Applicant : Cemal Shener et al.  
Serial No. : 10/685,590  
Filed : October 16, 2003  
Page : 11 of 16

Attorney's Docket No.: 00167-460001 / 02-31-0389

Amendments to the Drawings:

# ANNOTATED SHEET

FIG. 1F

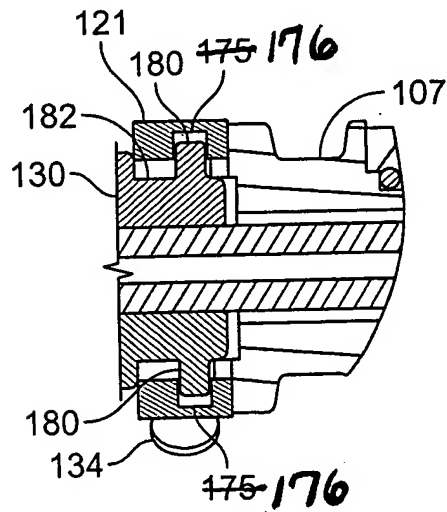
In Figure 1F, reference numeral "175" has been changed to reference numeral "176."

The drawings and the specification have been objected to as using the same reference character "175" to designate both an inflow port and L-shaped channels. Applicants have amended the drawings and the specification to use the reference character "176" to designate the L-shaped channels. Accordingly, applicants request reconsideration and withdrawal of this objection.
